Platt Technical High School

ADDENDUM NO. 4

August 9, 2019

1 FIRST FLOOR PLUMBING BELOW SLAB - AREA F
 1/8" = 1'-0"
 FFE: 07'
 REFER TO DRAWING P3-1-1 FOR PLUMBING LEGENDS.
 REFER TO DRAWING P3-1-2 FOR SCHEDULES & FIXTURE CONNECTION SCHEDULE.
 REFER TO DRAWINGS P4-1-1, P4-2 & P4-3 FOR PLUMBING DETAILS.

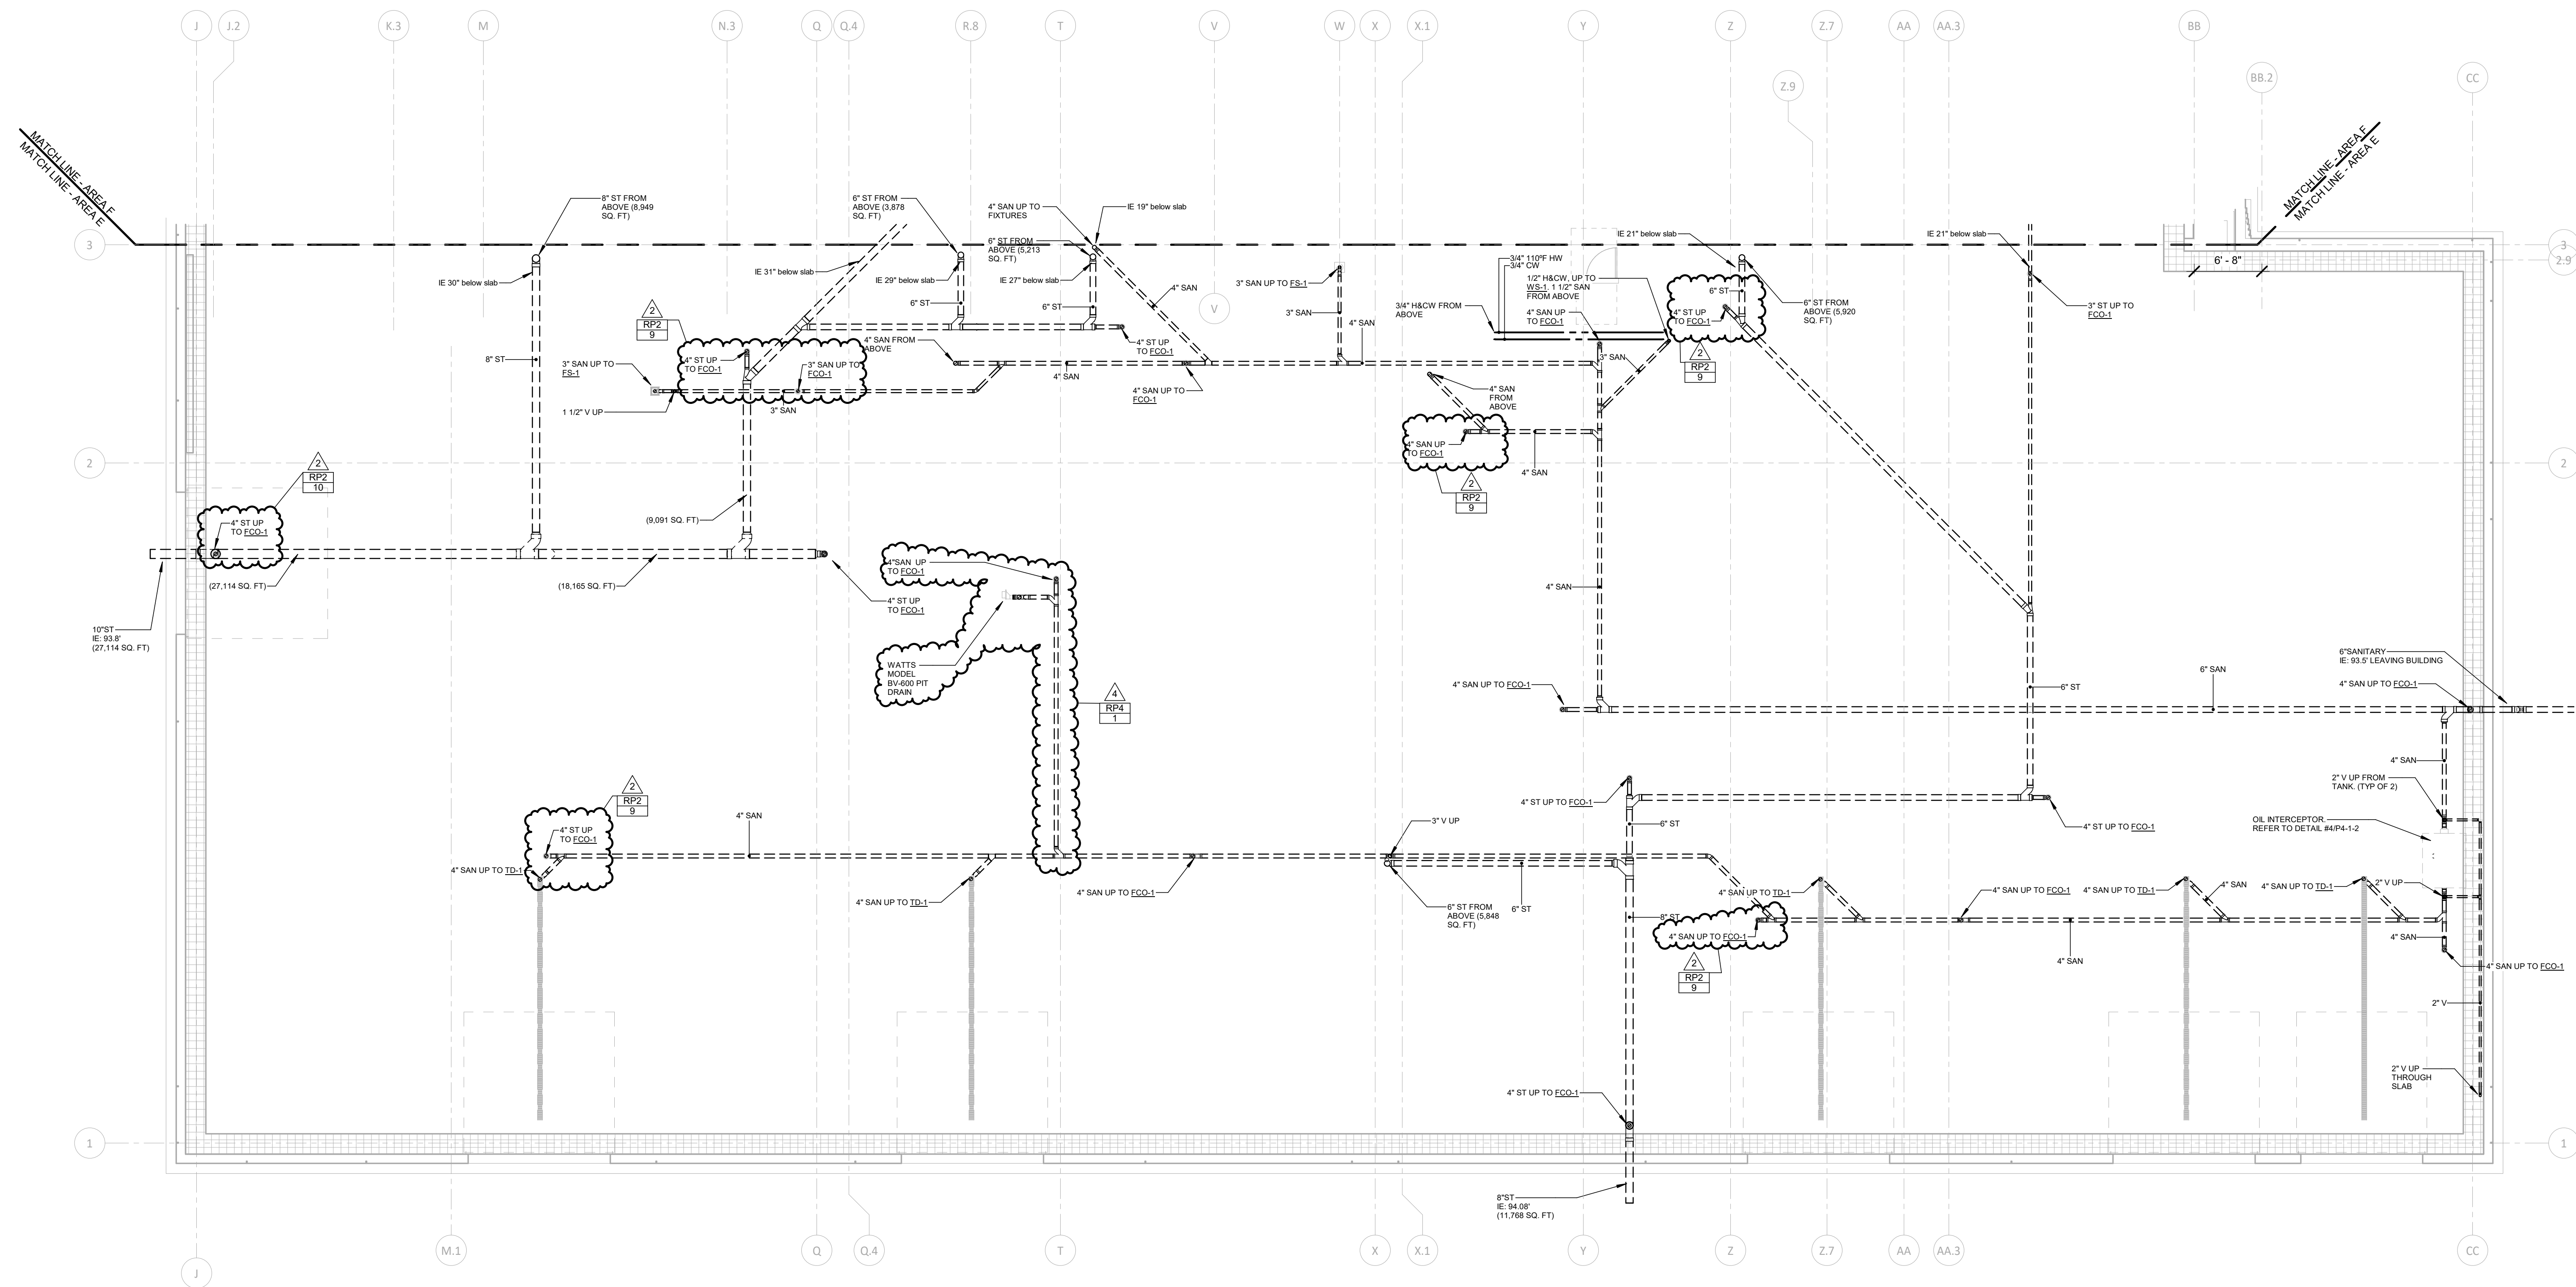
- ADD 4-139 DRAWING P-1-1-UF – BELOW SLAB PLUMBING PLAN AREA F**
Added pit drain and piping at recessed car lift, per Revision RP4-1.
- ADD 4-140 DRAWING P-1-1-1G – FIRST FLOOR PLUMBING PLAN AREA G – ALTERNATE NO. 2**
Updated note to include installation of backflow preventer, per Revision RP4-2.
- ADD 4-141 DRAWING P-3-1-2 – PLUMBING SCHEDULES**
Added HWR connection size and added notes to Plumbing Fixture Connection Schedule, per Revision RP4-3.

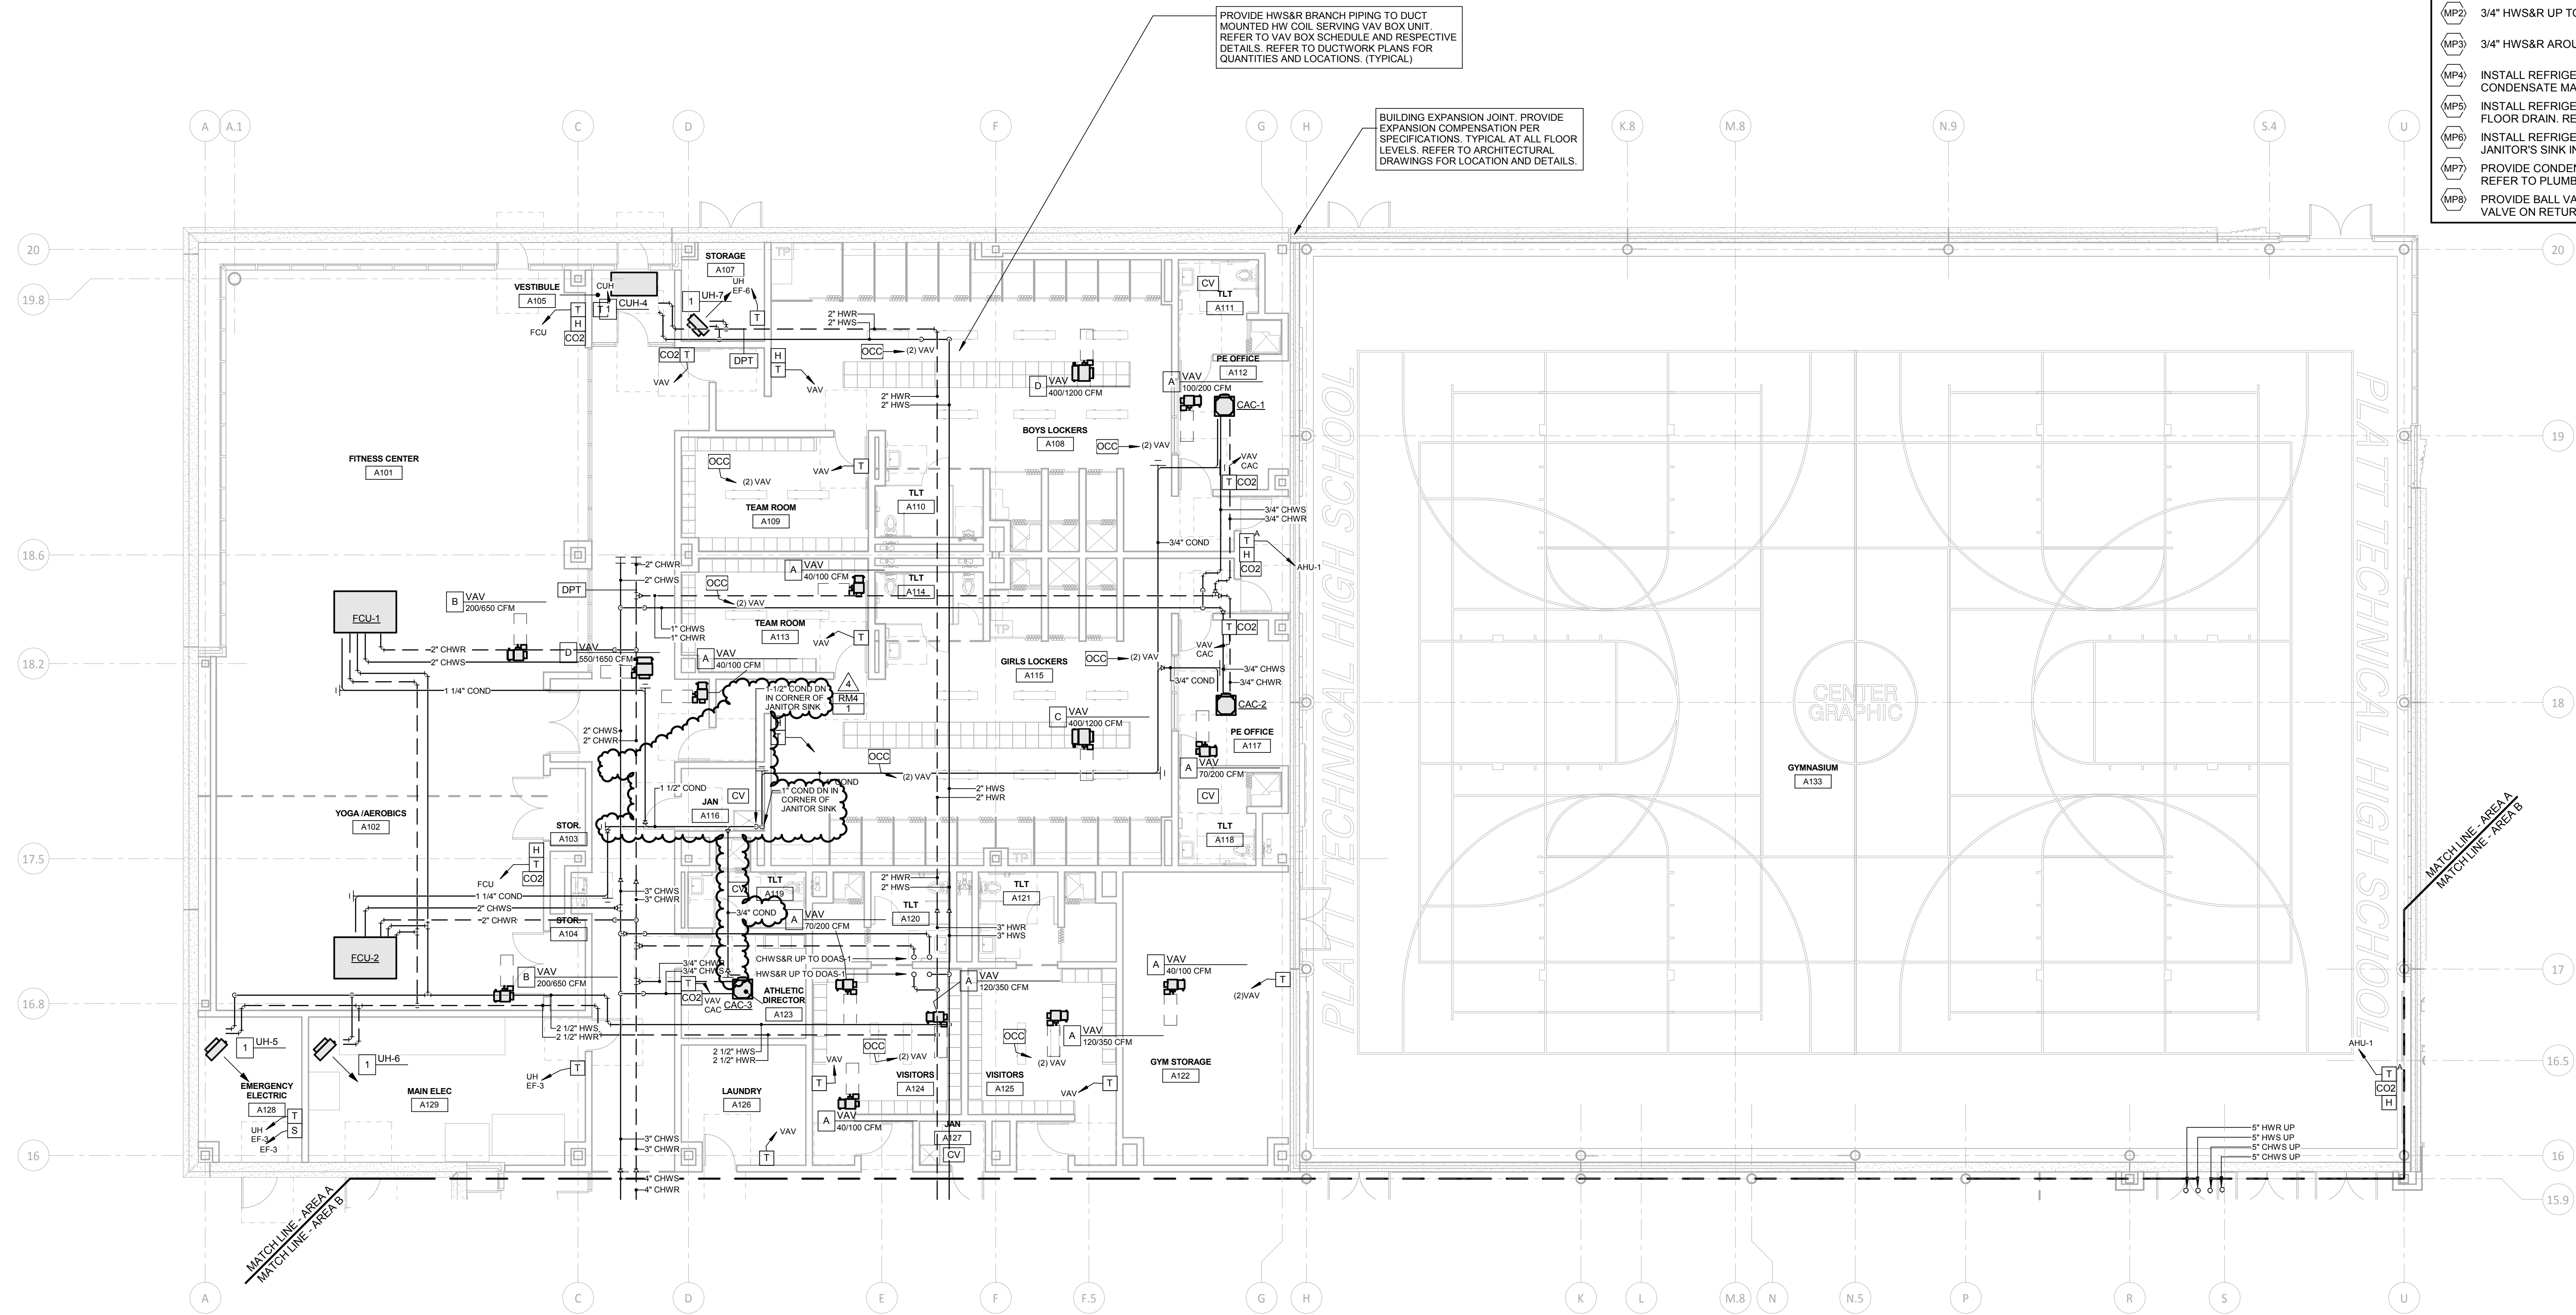
- ADD 4-142 DRAWING M2-1-1A – FIRST FLOOR MECHANICAL PIPING PLAN AREA A**
Updated condensate drain piping serving FCU's and CAC-3 per Revision RM4-1.
- ADD 4-143 DRAWING M4-1-3 – MECHANICAL DETAILS**
Revise Detail #2 regarding chiller relief vent piping per Revision RM4-2.
